Case No. 05-2188-cv-JPM-tmp

CONSENT ORDER

APPENDIX B.1
South Bluffs Apartments

APPENDIX C.1
Island Park Apartments
(Memphis, TN)
Exterior Accessible Route Plan
and Unit Plans

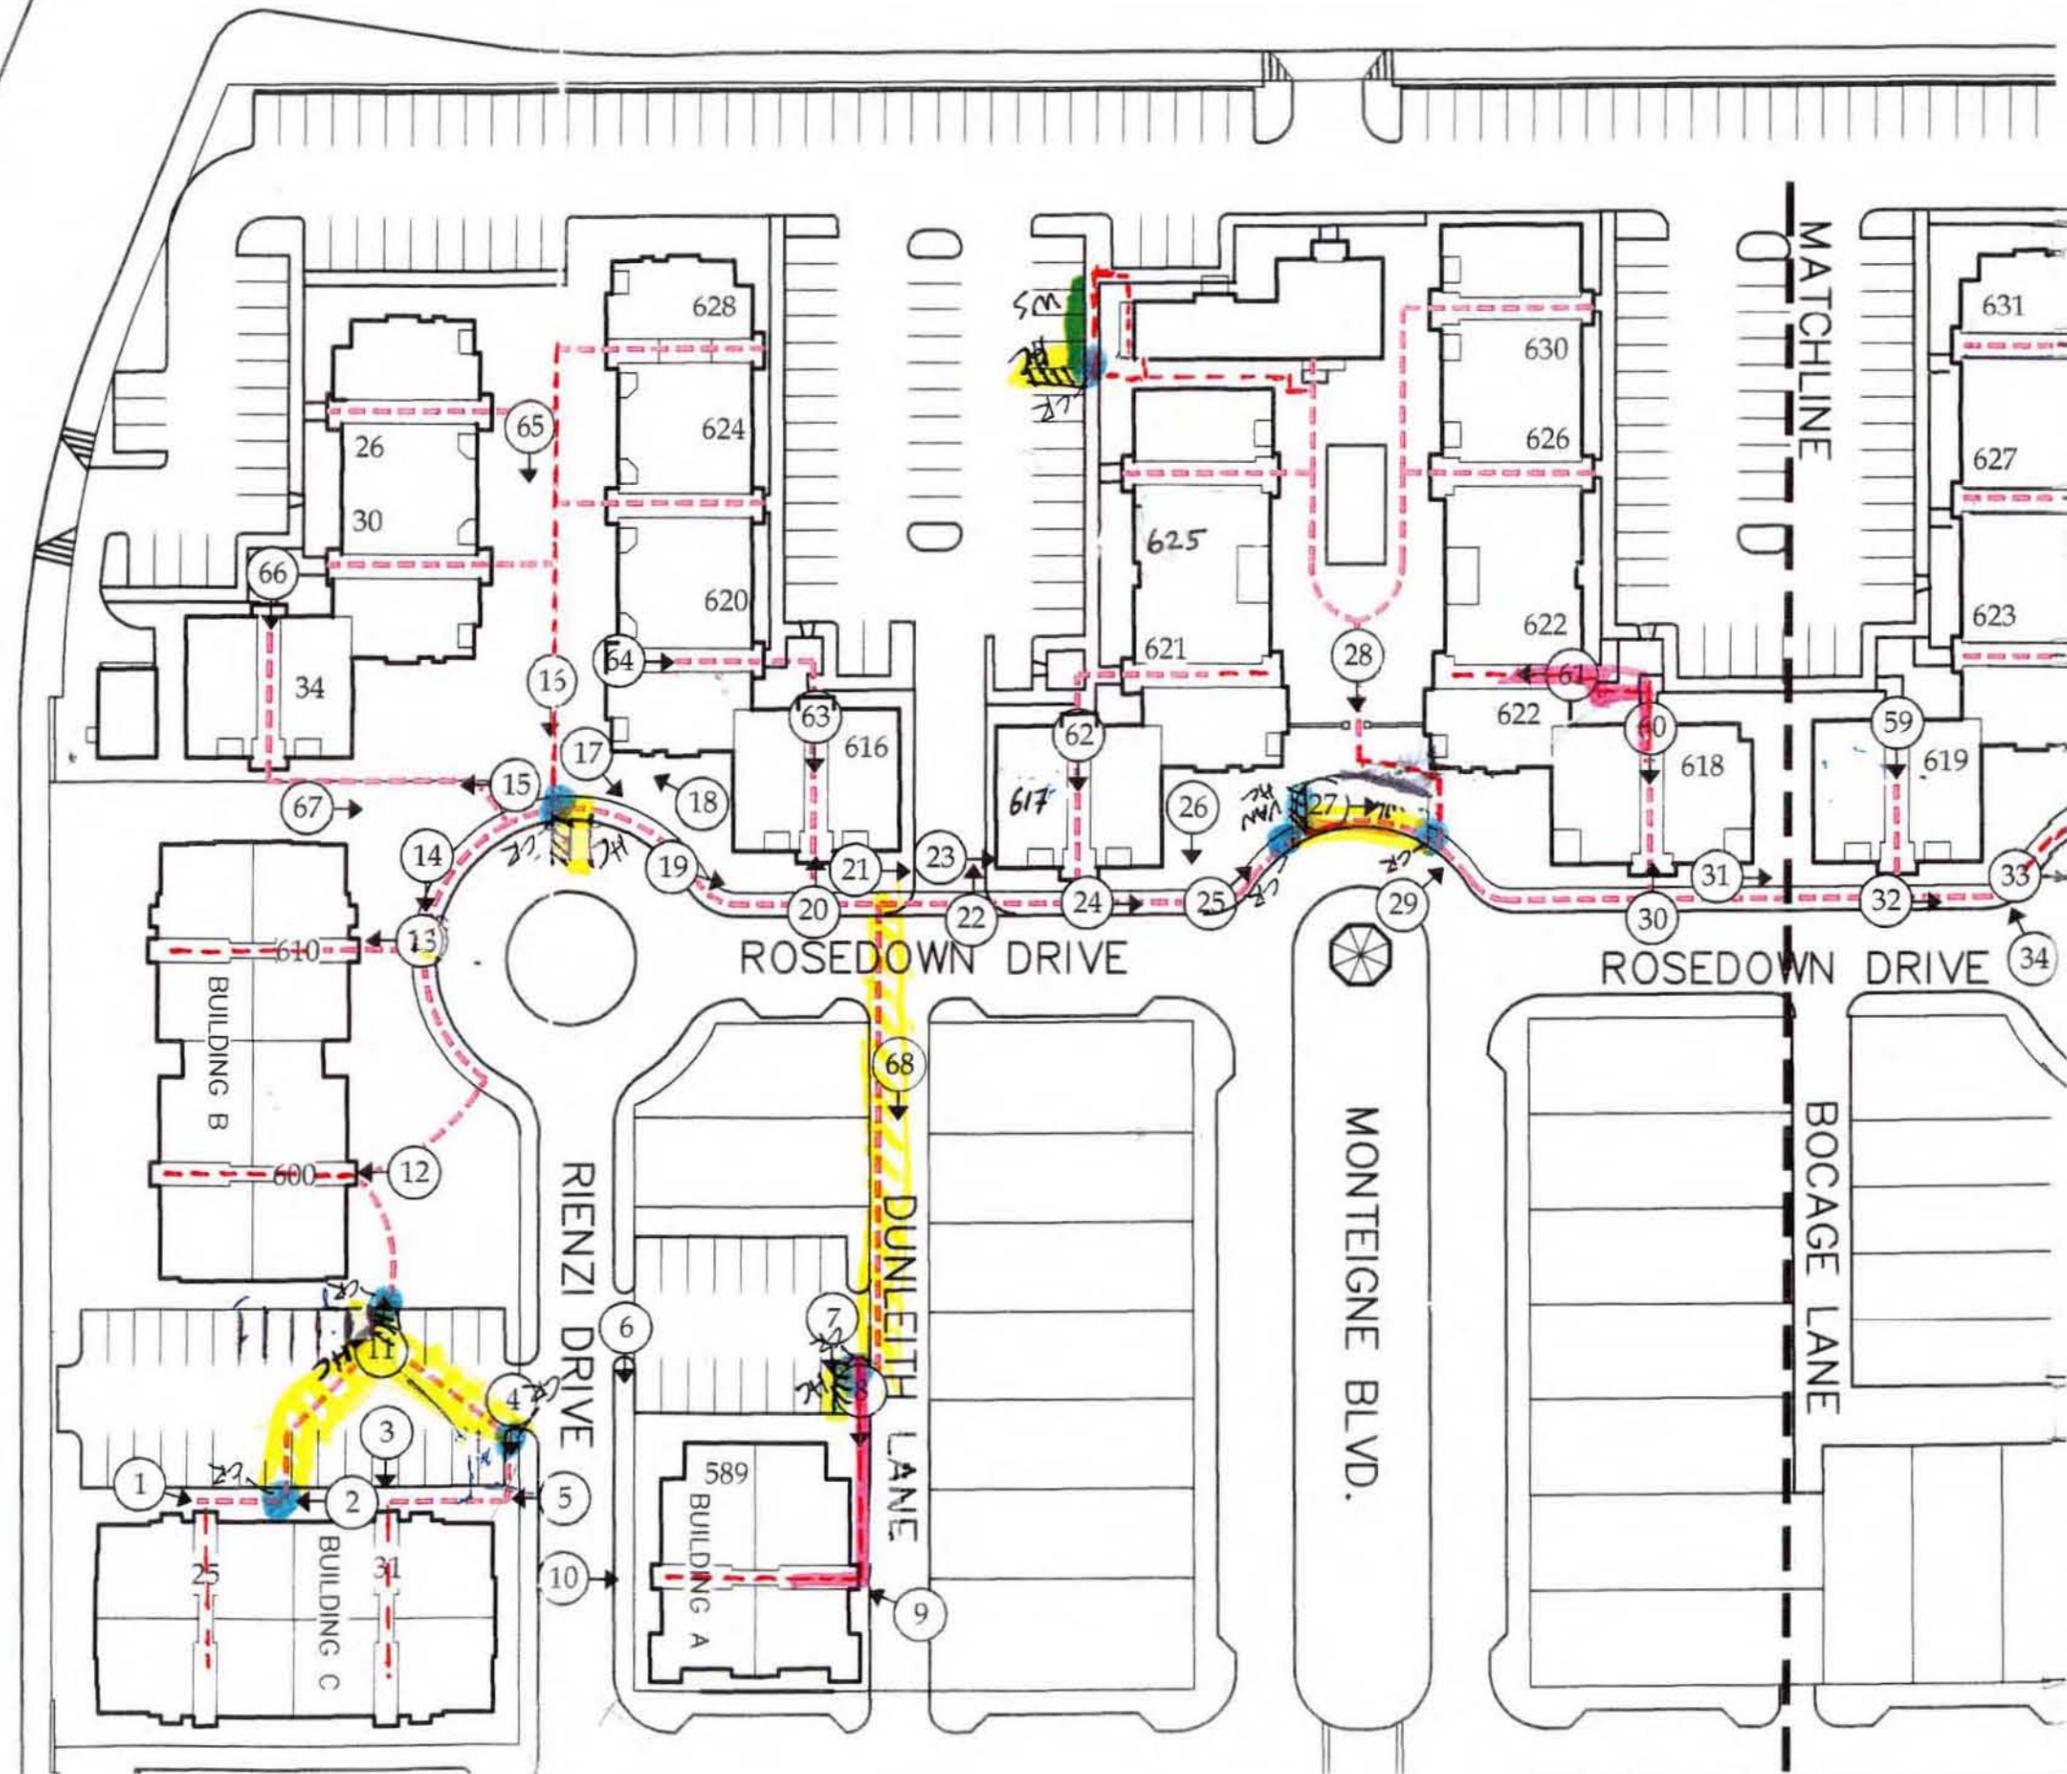
4	6	1	100 Riverview Dr. West (curb ramp east of breezeway is blocked by parked car)	Install wheel stops not less than 24" from the curb face along accessible route at 4 general locations-sidewalks along parking just south of breezeways 93, 97, 101 and 105; just east of breezeways 85, 81, 77, and 73; west side of building containing breezeways 96 and 100; and at east end of clubhouse/mailbox area - in accordance with the green highlighted areas on the Accessible Route Plan in Appendix B.1.
5	9	C.	At the following locations, the accessible routes from the parking area and public streets / sidewalks to the building entrances have abrupt level changes greater than 1/4" without bevel or ramp features.	On accessible routes, bevel 1/2" level changes at 1:2 and retrofit all vertical level changes greater than 1/2" to make ANSI compliant.

Violation	Retrofit
6	10	1	101 Riverview Dr. West (1/2" asphalt lip at bottom of curb ramp)	The existing curb ramp with 1/2" asphalt lip west of entrance to breezeway #101 and #105 is not on the accessible route because new ANSI complaint curb ramp and accessible parking space will be installed on the east side of building to provide access to #101 and #105.	
7	11	2	93 Riverview Dr. West (5/8" lip at breezeway entry)	Retrofit 5/8" lip at breezeway entry to #93 and #97 to comply with ANSI.	
8	14	5	616, 617, 618, 619 Charleston Court (6" high curb without curb ramp at pedestrian approach from Rosedown Drive)	The 6" high curbs will not be on accessible route because access to ##616, 617, 618, and 619 will be from newly installed ANSI compliant sidewalk along south side of Rosedown according to Appendix B.1, Accessible Route Plan.	
9	16	7	631 Charleston Court (1 3/4" lip at west breezeway entry)	Access to #631 is from courtyard at west entrance. Retrofit 1 3/4" lip at west breezeway entry to make ANSI compliant.

Violation	Retrofit
15	24	15	620 Cabot Court (3 steps at east breezeway entry)	Reconstruct walks around landscape circle on Cabot Court at west side of building to provide ANSI compliant access from #616 to #620.
16	25	16	624 Cabot Court (3 steps at west breezeway entry and 2 steps at east breezeway entry)	Access to #624 is via courtyard at east entrance connecting to North (Rosedown). Retrofit route and steps from east by installing new ANSI compliant ramp to eliminating steps and installing new ANSI compliant curb ramp and accessible parking at north entry of courtyard.
17	26	17	628 Cabot Court (3 steps at west breezeway entry and 3 steps at east breezeway entry)	Access to #628 is via courtyard at east entrance connecting to North (Rosedown). Retrofit route and steps from east by installing new ANSI compliant ramp to eliminate 3 steps at east breezeway entry.
18	27	18	30 Riverview Dr. East (1" lip at approach walk northwest of curb ramp and ½" lip at west entry of breezeway)	Access to #30 is from courtyard at west entrance. Bevel 1/2" lip at 1:2 at west breezeway entry.

Violation	Retrofit
29	45	12	620 Cabot Court (west approach walkway has 3.3% cross slope just north of the adjacent designated accessible parking space)	Reconstruct walks around landscape circle on Cabot Court at west side of building to provide ANSI compliant access from #616 to #620, including retrofitting 3.3% cross slope to comply with ANSI 4.3.7.
30	47	14	34 Riverview Dr. East (east approach walkway has 5.5% cross slope along the southern walkway from the adjacent designated accessible parking space, a 3.4% cross slope along the pedestrian approach walkway from the north and a 5.4% cross slope along the circular walkway between 610 Rienzi Drive and the north breezeway of this building)	Retrofit 3.4% and 5.4% cross slopes on north walk and circular walk to comply with ANSI 4.3.7. 5.5% cross slope is not on accessible route. See Appendix B.1.
31	49	16	25 Nottoway Blvd. (access aisle of the designated accessible parking space has a cross slope of 2.5%, the ramp leading from this parking space to the south breezeway has a cross slope of 3.5% and the sidewalk between the on-street parking along Nottoway Blvd. And the north entry breezeway has a cross slope of 3.3%.)	Retrofit 3.5% cross slope on ramp on south side of #25 to comply with ANSI; and stripe access aisle and crosswalk on south side of #25 to connect with access aisle for new ANSI compliant curb ramp to #600. 3.3% cross slope at north entry breezeway is not on accessible route.

32	50	17	31 Nottoway Blvd. (the ramp leading from the sidewalk along Rienzi Drive to the south breezeway has a cross slope of 8.3% at the bottom and 6.5% near the top, the sidewalk along Rienzi Drive has a cross slope of 3.1% and the sidewalk between the on-street parking along Nottoway Blvd. And the north entry breezeway has a cross slope of 3.0%)	Install new ANSI compliant ramp at southwest corner of building to provide access to #31 via retrofitted ANSI compliant south walk, and retrofit 8.3%, 6.5%, and 3.1% cross slopes on the walks to comply with ANSI 4.3.7. The 3.0% cross slope at the north entry to the breezeway is not on the accessible route.
	52	E.	There is no accommodation for accessible resident or visitor parking from which building entrances at the following buildings may be approached on an accessible route:	
33	53	1	The building made of 600 & 610 Rienzi Drive	Install new ANSI compliant accessible parking space and curb ramp on the circle connecting Rosedown Drive to Rienzi Drive at north end of courtyard to #620 and #30, and install ANSI compliant accessible parking space and curb ramp to north of #600 at south side of parking south of #31 breezeway. See Appendix B.1, Accessible Route Plan.

Violation	Retrofit
41	68	8	38 Riverview Dr. West (approach walk slopes 6.4% at the east breezeway entry and 9.6% at the ramp between this breezeway entry and the designated accessible parking space just to the south)	Retrofit walk by installing ANSI compliant handrails on both sides at east entrance. Access to #38 will be via courtyard at east entrance with new ANSI compliant curb ramp and accessible parking at north entry of courtyard according to Accessible Route Plan in Appendix B.1. 9.6% is not on accessible route.
42	71	11	618 Charleston Court (approach walk slopes 6.0% at south breezeway entry)	Access to #618 is from North (Rosedown) and South (connecting to #622). Retrofit 6.0% slope at south breezeway entry to comply with ANSI 4.3.7.
43	72	12	626 Charleston Court (approach walk slopes 7.2% at west breezeway entry and 14.2% at the east breezeway entry)	Access to #626 is from east courtyard and to North (Rosedown), so retrofit 14.2% at east breezeway entry to comply with ANSI 4.3.7. 7.2% at west breezeway entry is not on accessible route.

44	74	14	617 Cabot Court (approach walk slopes 6.3% at south breezeway entry)	Retrofit 6.3% slope at south breezeway entry to comply with ANSI 4.3.7.
45	75	15	616 Cabot Court (approach walk slopes 13.9% at south breezeway entry)	Retrofit 13.9% slope at south breezeway entry to comply with ANSI 4.3.7.
46	77	16	620 Cabot Court (approach walk slopes 8.4% at west breezeway entry)	Reconstruct walks around landscape circle on Cabot Court at west side of building to comply with ANSI and provide access from #616 to #620, and retrofit 8.4% slope at west breezeway entry to comply with ANSI 4.3.7.
47	79	18	26 Riverview Dr. East (approach walk slopes 12.0% at the brick header just south of the central seating area in the adjacent courtyard)	Retrofit 12.0% slope at brick header in courtyard south of seating area to comply with ANSI 4.3.7.
48	82	21	610 Rienzi Drive (approach walk slopes 8.8% at west breezeway entry)	Retrofit walk by installing ANSI compliant handrails on both sides of approach walk at west breezeway entry.
